**TOWN OF BAY HARBOR ISLANDS
DEVELOPMENT & REVIEW COMMITTEE MEETING
THURSDAY, FEBRUARY 9, 2023**

1. Review and discussion of Site Plan Application by DDG 100 Street BHI, LLC, to construct an 18-unit Multi-Family Development to be located at 1130 - 1140 100 Street. Enclosed are the Site Plans and the Staff Report prepared by Town Planner Michael Miller.
2. Review and discussion of Site Plan Application by LDC WBHD Property Owner, LLC, to construct a 9-unit Multi-Family Development to be located at 9110 West Bay Harbor Drive. Enclosed are the Site Plans and the Staff Report prepared by Town Planner Michael Miller.
3. Review and discussion of Site Plan Application by 1177 Bay Harbor Islands, LLC, for a revision to the previously approved New Commercial Mixed Used Building to be located at 1177 Kane Concourse. Enclosed are the Site Plans and the Staff Report prepared by Town Planner Michael Miller.

Subject: Site Development Plan Application (#2 Review)
1130 - 1140 100th Street – New Multi-family Residential Complex (18 DU)
Bay Harbor Islands Acct. No.: SPR23-000001
MMPA Acct. No. 01-0702-1151

TITLE
SITE PLAN

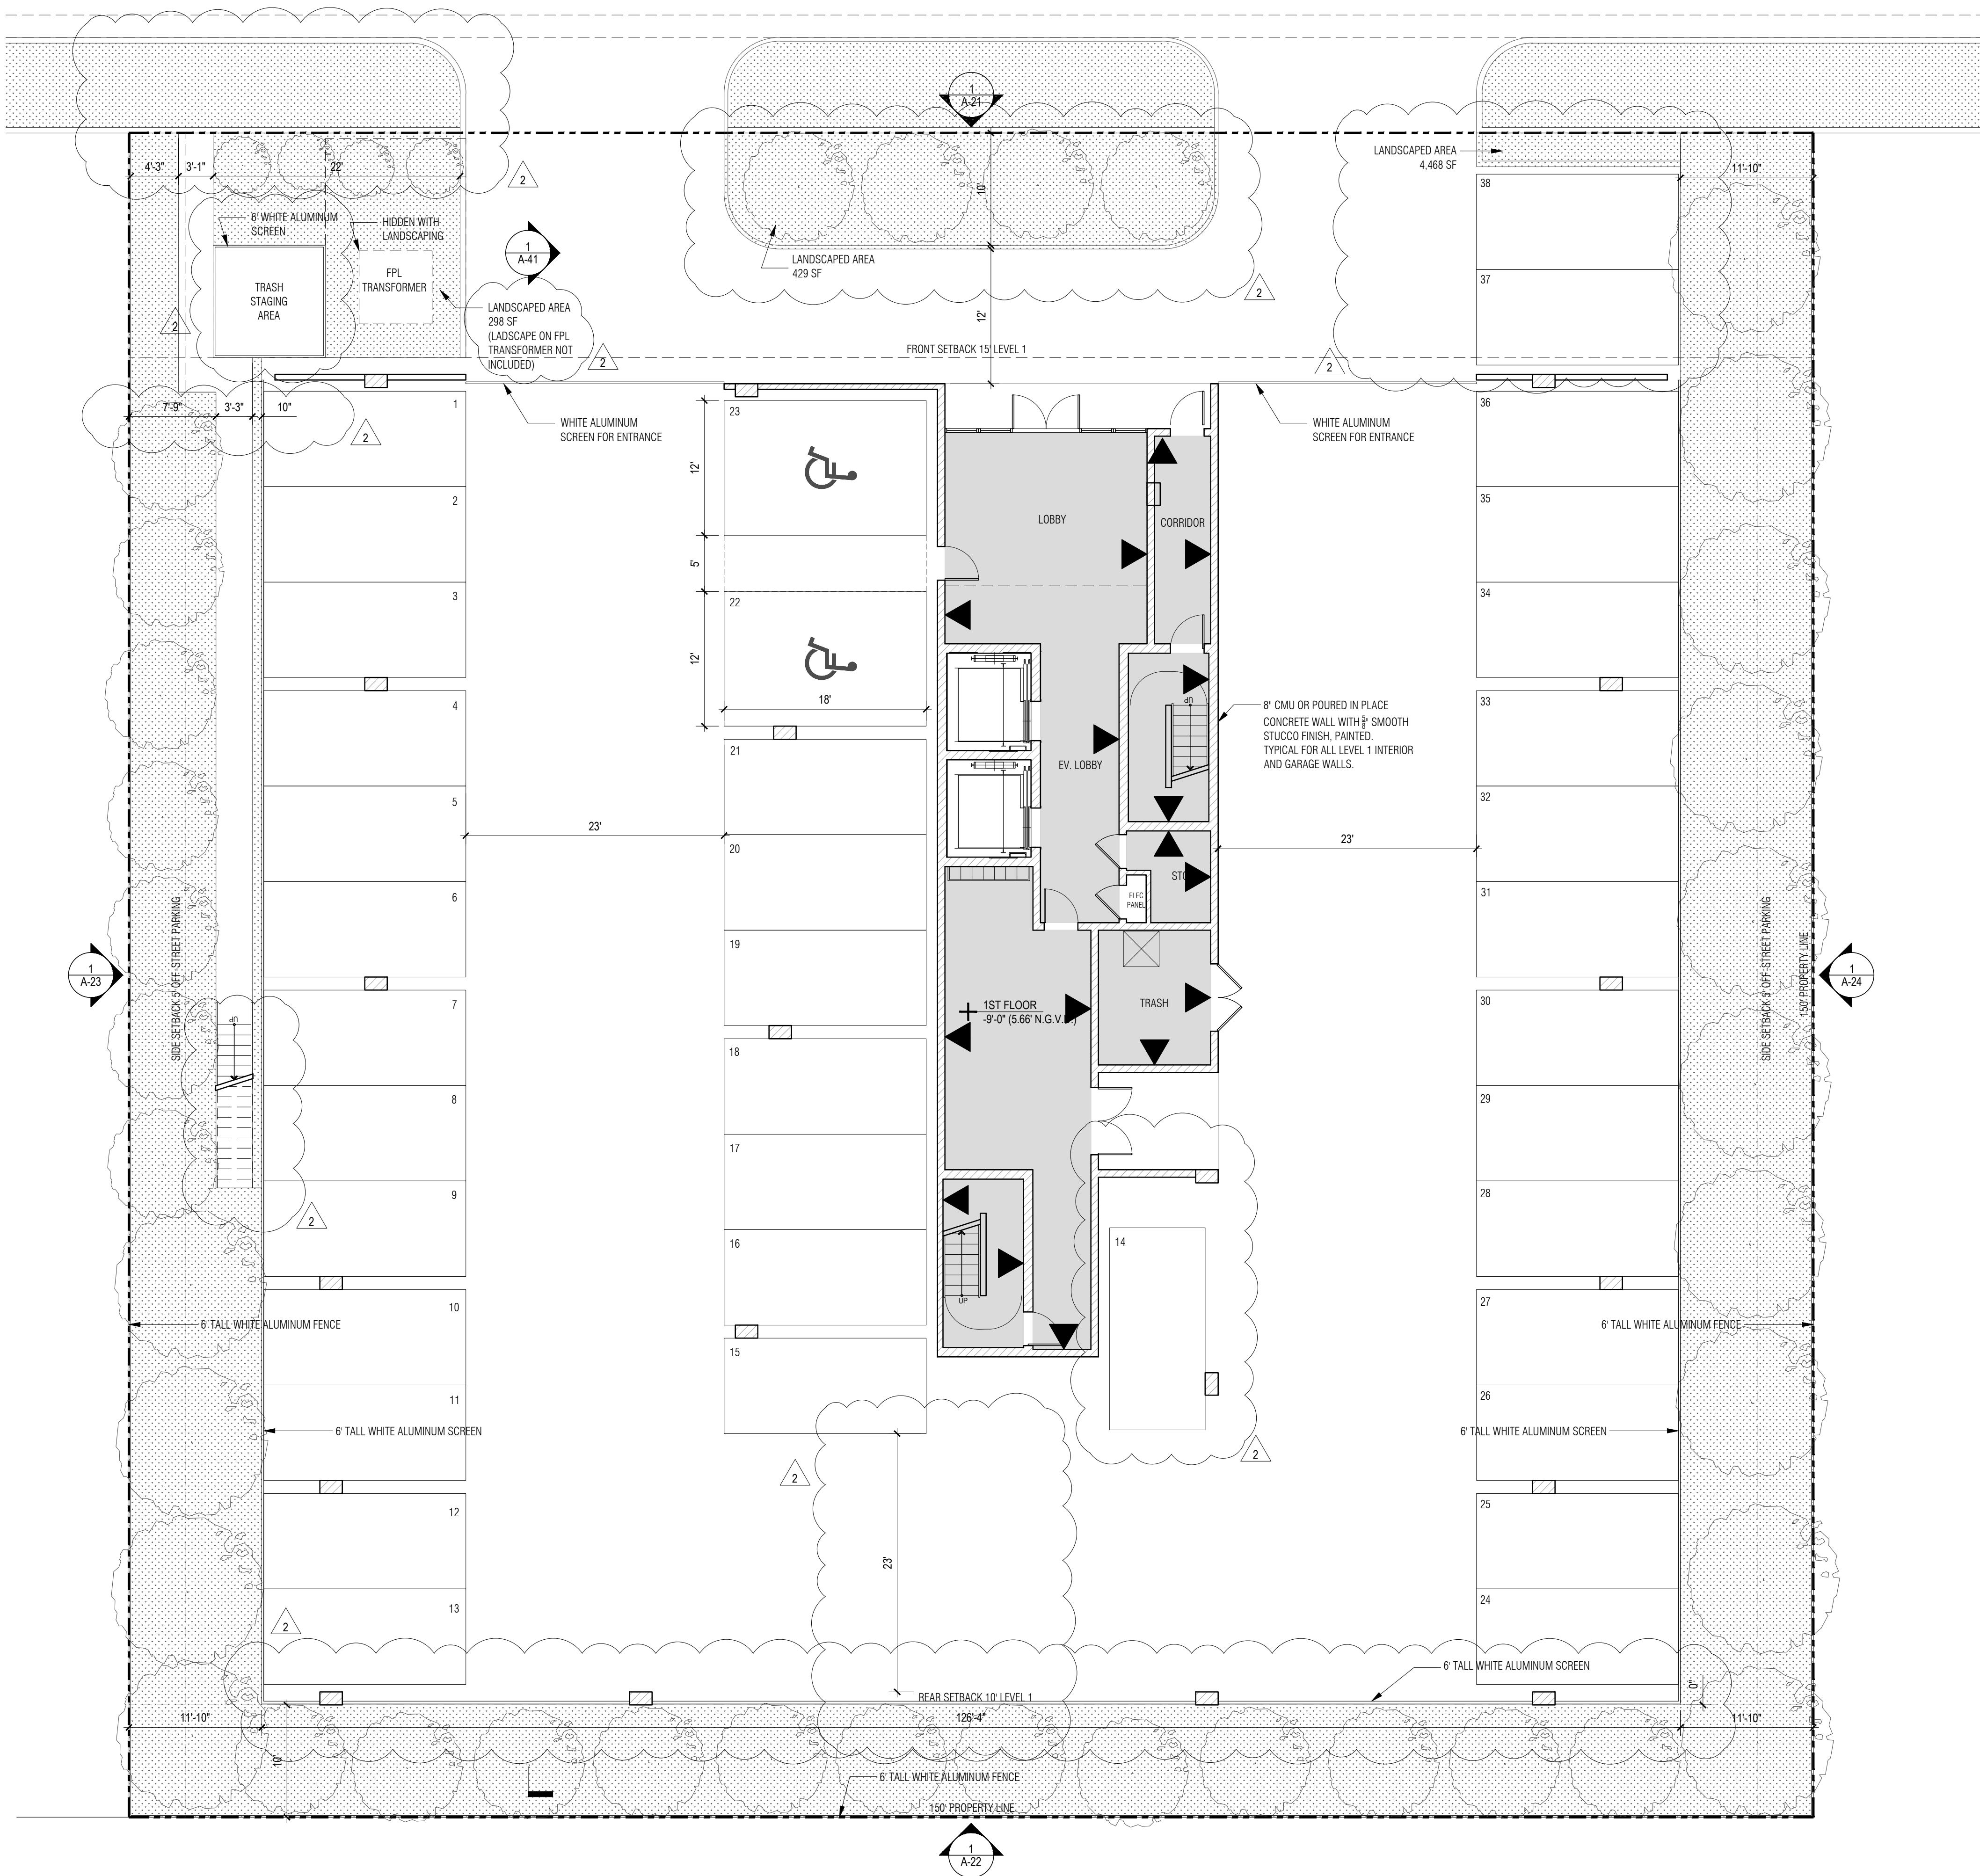
- 1) On Sheet A-06, A-11, PD-2 and several others (civil engineering / landscaping) the plans show that the proposed width of the required landscape strip along 100th Street at the northeast corner of the property adjacent to a guest space is less than the 10' required by Town Code. The plans do not include a width dimension for the landscape strip – the width scales to about 3' near the northeast corner of the property. Sec. 24-16(c)((3)(5) of the Code requires a min. 10' landscape strip width between a front property line and any on-site paved area. The Miami-Dade Countywide Landscape Code (Ch. 18A) requires at least 7' of width. Municipalities are allowed to have more restrictive criteria – and the Town does as an upscale community. The Town's DRB has the ability to approve waivers but has been reluctant to do so without cause. Dimension each landscape strip shown. Curbing is not part of the landscaped strip width. If the landscape strip dimensions are less than 10' provide a justification explaining the rationale for the request for the Town to consider.

- 2) Sec. 23-24(c) requires that guest parking / delivery spaces must be located in the front setback areas near the lobby entrance. The revised plans now show the 2 guest spaces in the front yard relocated from inside the garage, which would require special DRB approval. Two guest spaces are still required as the site exceeds one lot. But the landscape strip width issue must also be considered. Revise the plans to comply with Code.

TITLE
2ND FLOOR
FLOOR PLAN

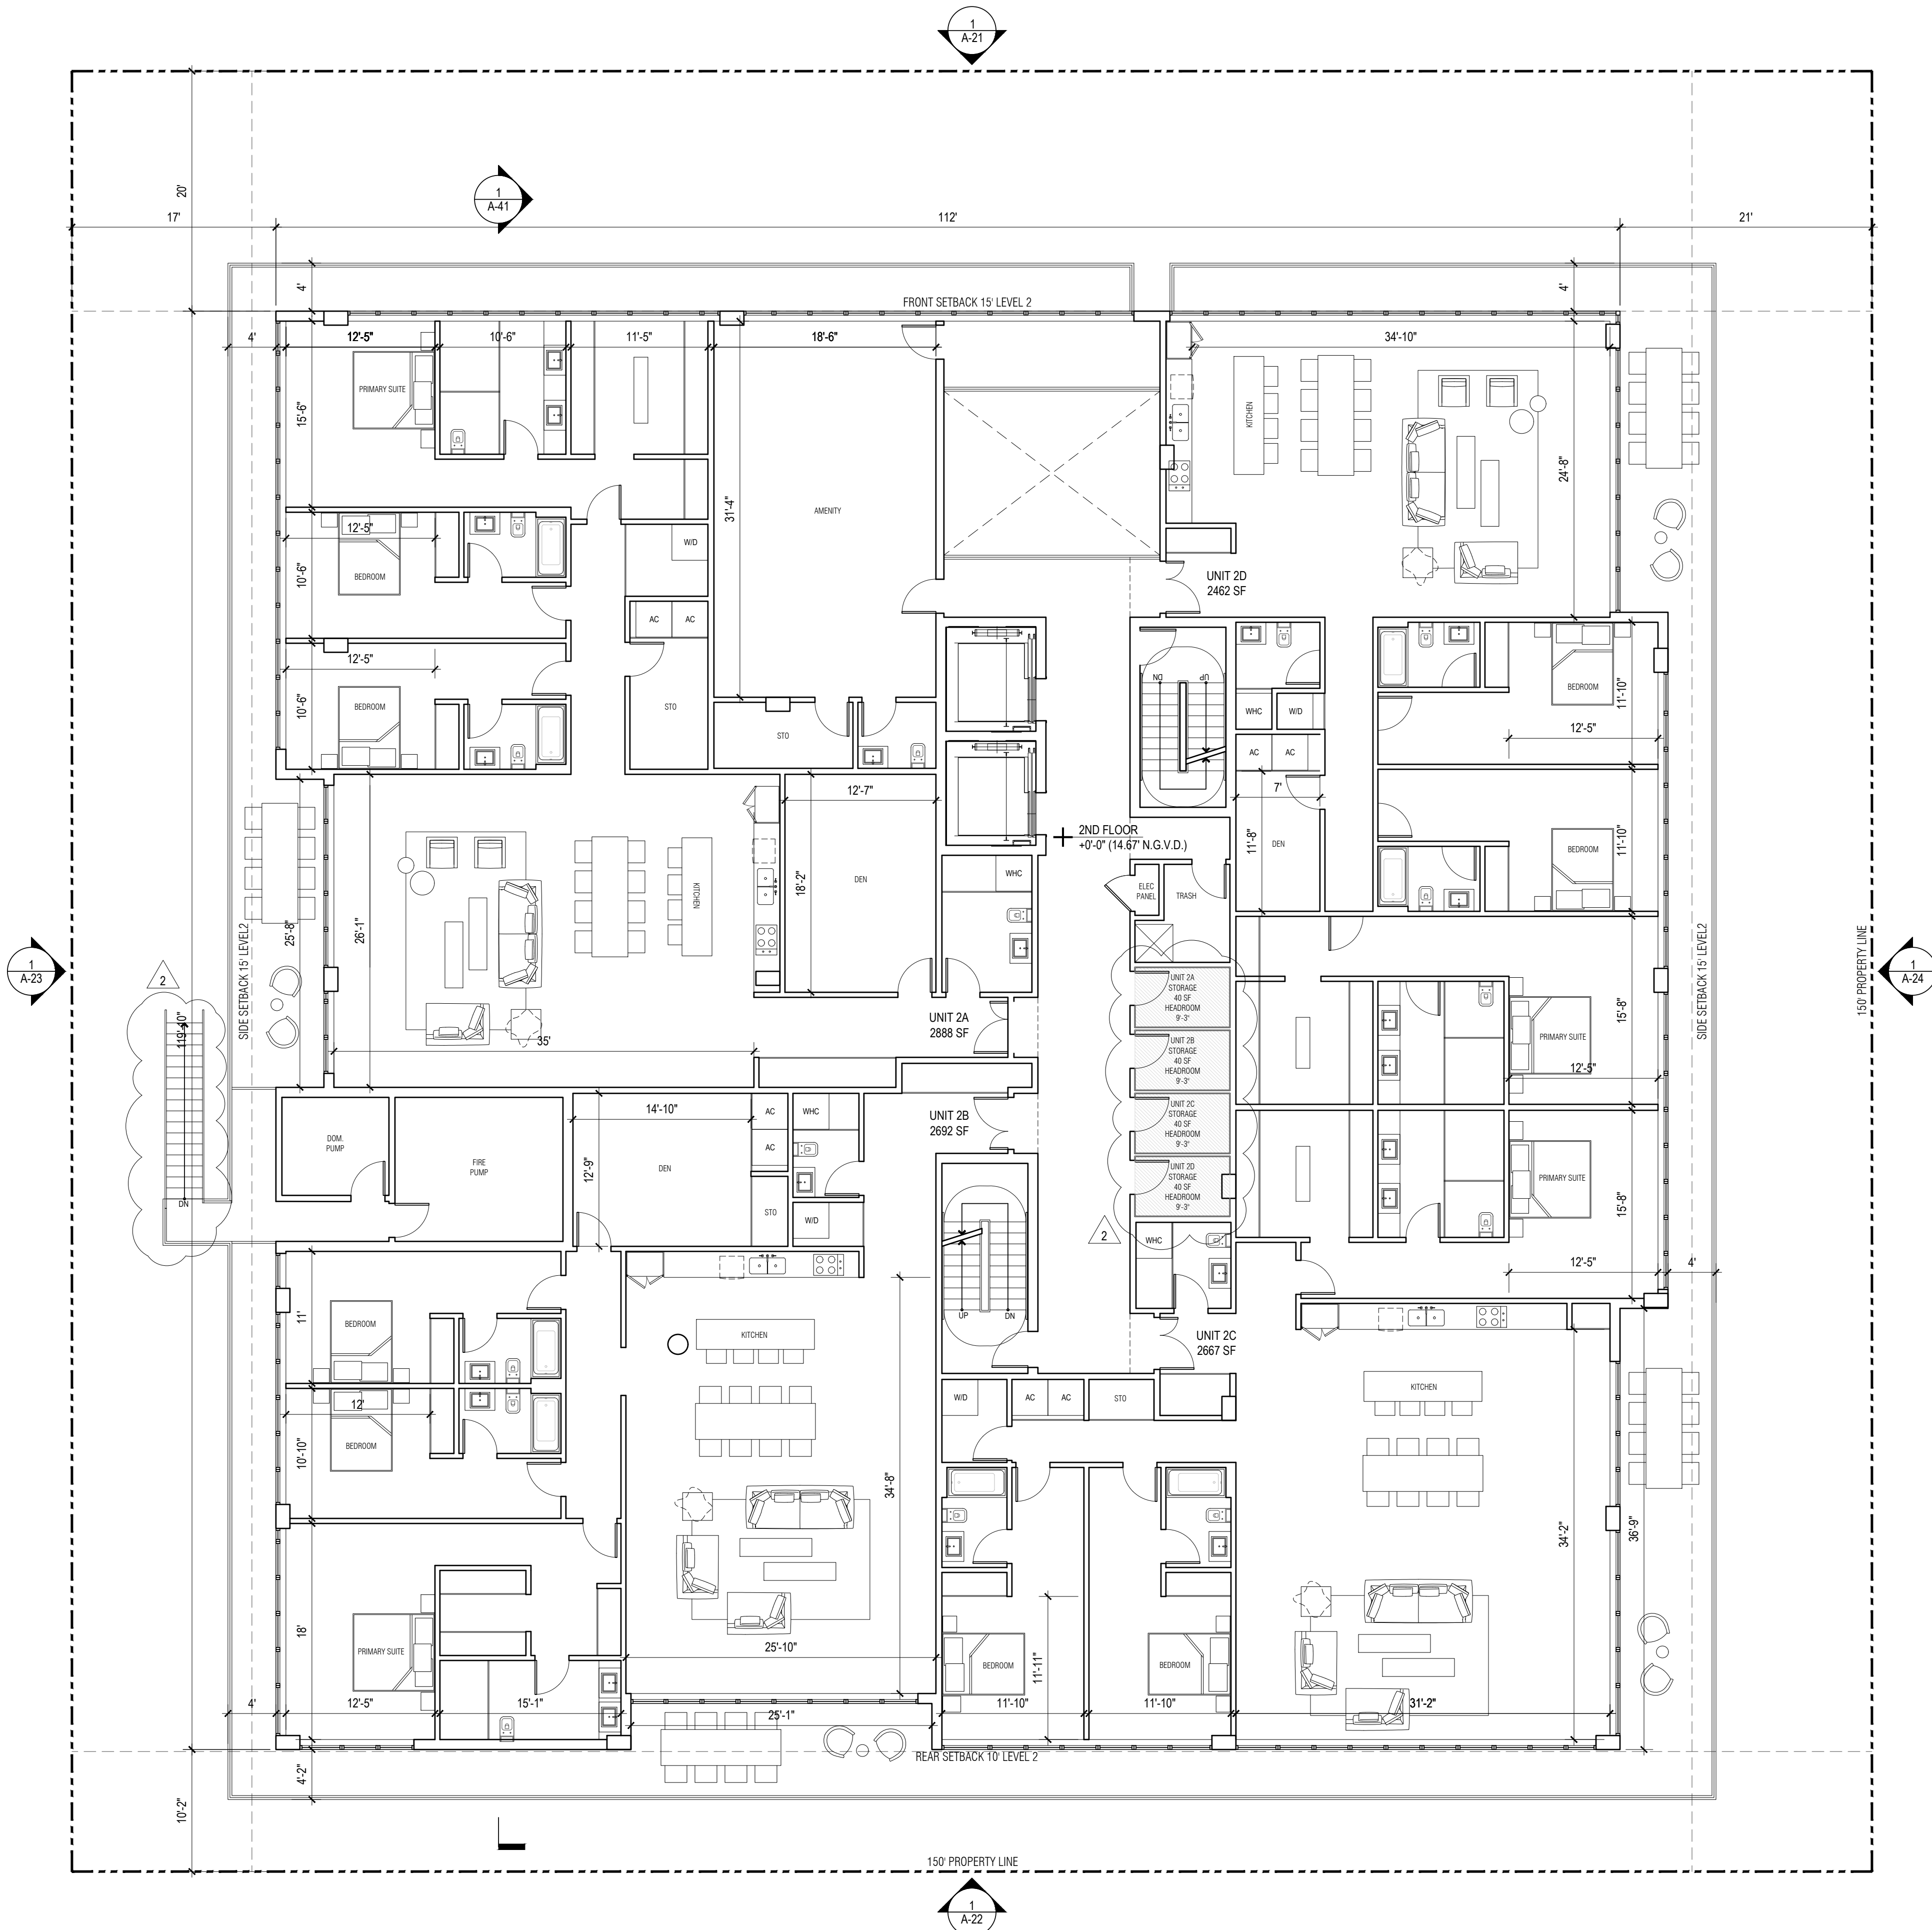
17)	The site plan set appears to be missing Sheet A-12 - the 2nd Floor Plan.	Plans have been revised accordingly. Please see sheet A-12.
18)	On Sheet A-06 include the applicable Comprehensive Plan FLUM category (Residential Medium-High Density 6-34 DUA). Revise the plans.	Plans have been revised accordingly. Please see sheet A-06.
